January 30, 2019

**Resolution Copper Project**  
**DEIS Design for Alternative 6 - Skunk Camp Doc. # CCC.03-81600-EX-REP-0006 - Rev.2**  
**Appendix IV Seepage Estimate Amendment**

## Appendix IV Alternative 6 - Seepage Estimate Amendment

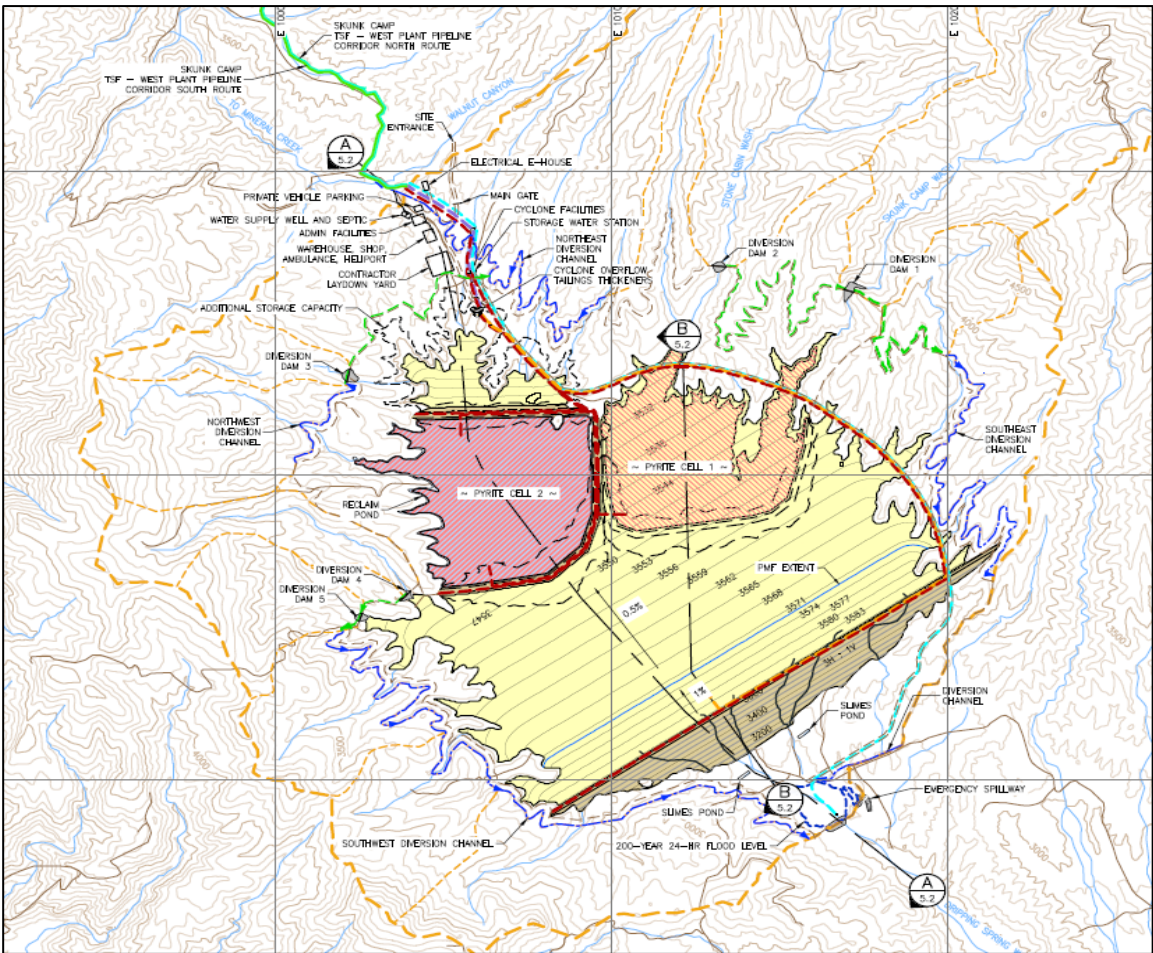
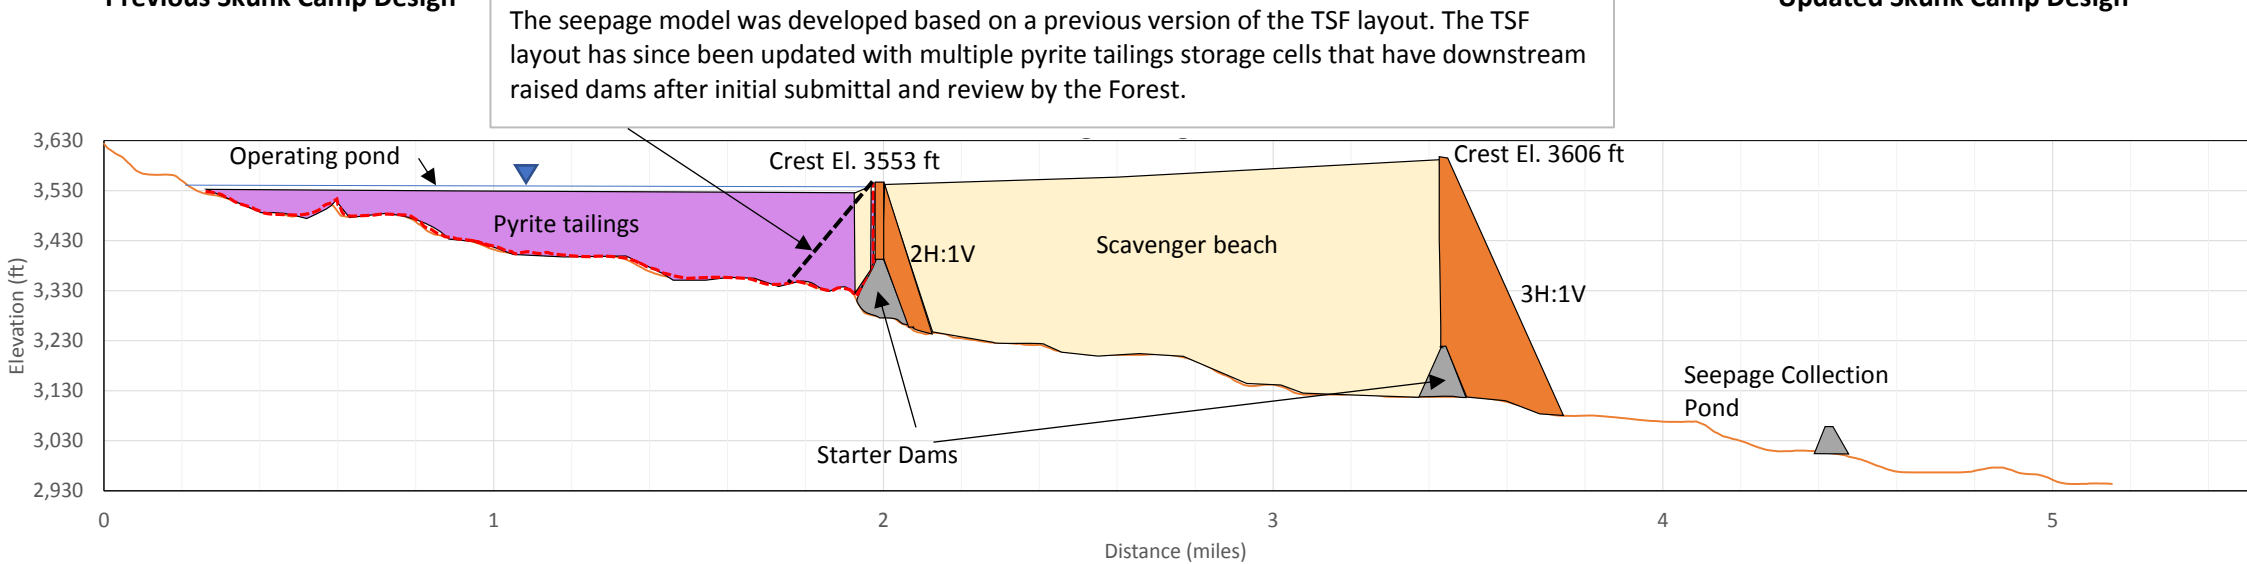
The seepage model was developed based on a previous version of the TSF layout. The TSF layout has since been updated after initial submittal and review by the Forest to reduce the exposed Pyrite Cell pond surface area as a best practice technology for the management of pyritic material, to limit the effect of evaporation and reduce the area of seepage and overall improve water management. The revised layout consists of two pyrite cells: Pyrite Cell 1, operated from Year 1 to Year 15 and subsequently covered by scavenger tailings in Year 16, and Pyrite Cell 2, operated from Year 16 to Year 41. The seepage model is assumed to be appropriate for the new layout because of the similar configuration in two-dimensions (2D), as shown on Figure IV-1.
